CITY OF BURBANK
COMMUNITY DEVELOPMENT DEPARTMENT

Subject: Pickwick Gardens, SB 35 Notice of Intent Second Submittal Review

The City of Burbank has reviewed your second submittal of the Notice of Intent (NOI) for Streamlined Ministerial Approval Process of a proposed multi-family residential project located at 1001 W. Riverside Drive (generally referred to as Pickwick Gardens) (**Proposed Project**). Your original NOI was received on July 1, 2021, which the City reviewed and deemed incomplete on July 30, 2021. Your second submittal was received in piecemeal fashion throughout September and October as summarized below.

PRELIMINARY GRADING AND DRAINAGE PLAN
RIVERSIDE DRIVE / SOUTH MAIN STREET, BURBANK, CALIFORNIA

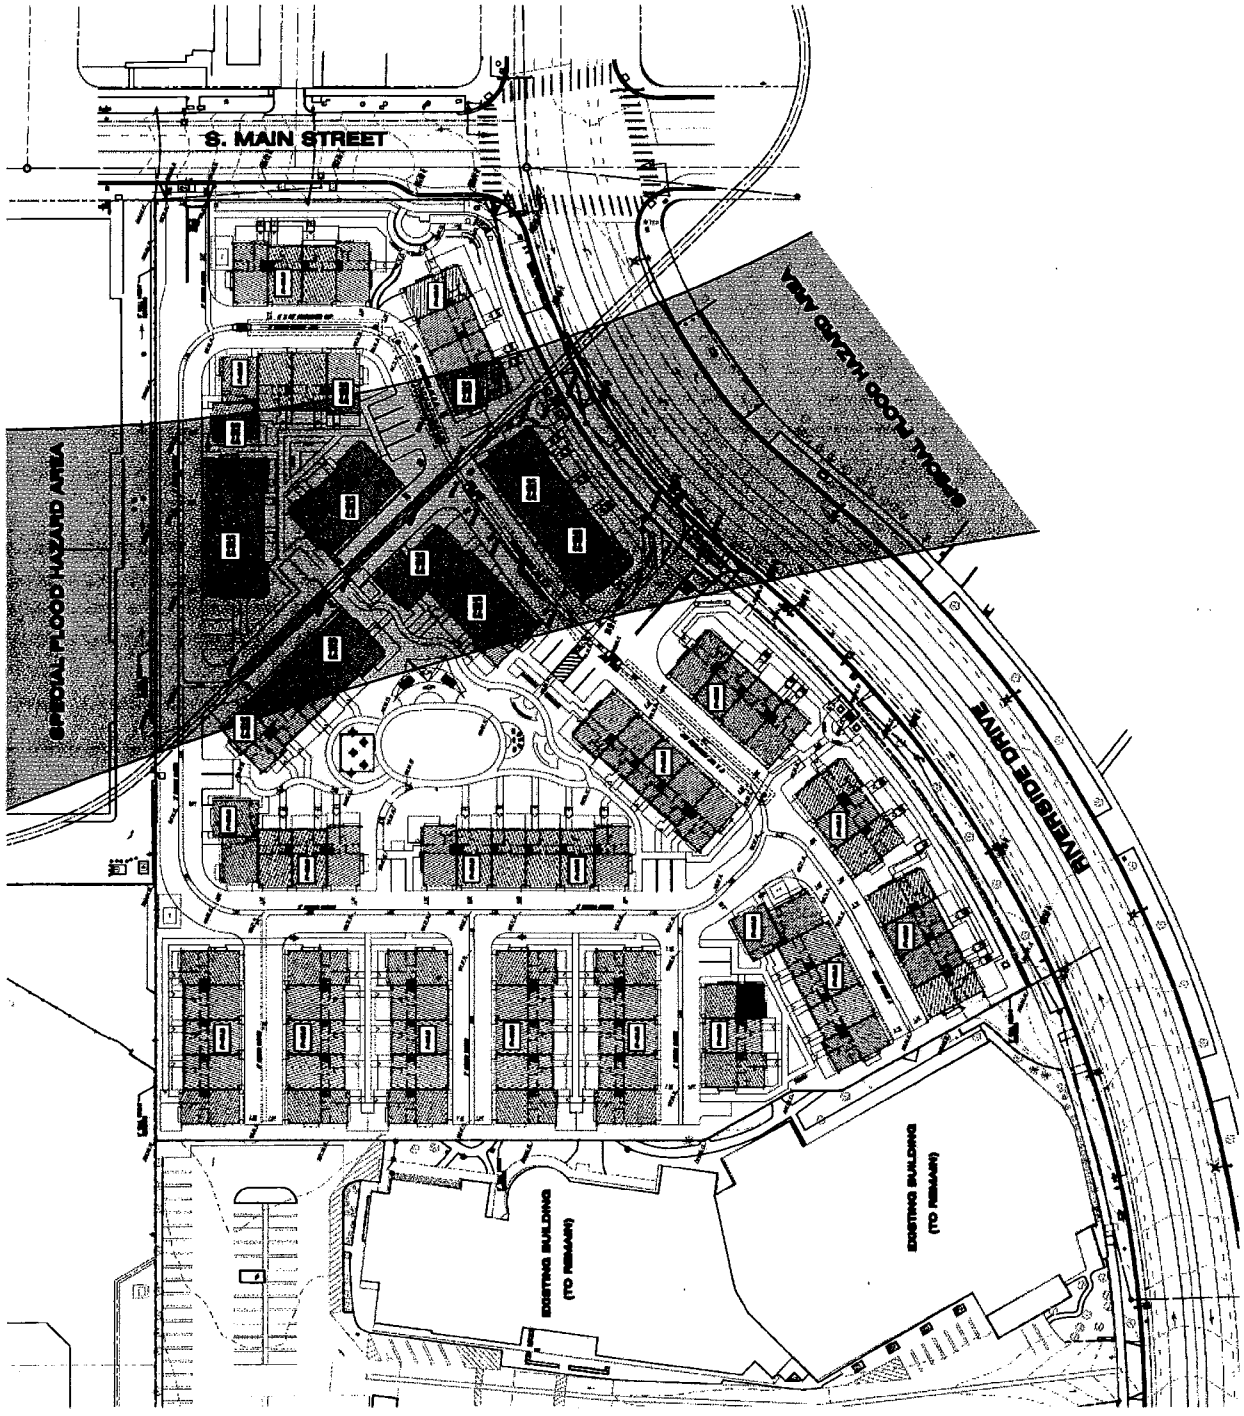
With respect to the second criterion, as shown on Exhibit C in the Project Applicant's memorandum titled "Preliminary Grading and Drainage Plan," the Proposed Project will include adequate drainage around structures on slopes, to guide storm and floodwaters around and away from the proposed residential structures. The Proposed Project will include slopes of 2% or more grade away from structures. With this proposed infrastructure, the Proposed Project will provide adequate drainage around structures on slopes to guide storm and floodwaters around and away from proposed structures. As such, the Proposed Project will comply with the second criterion.
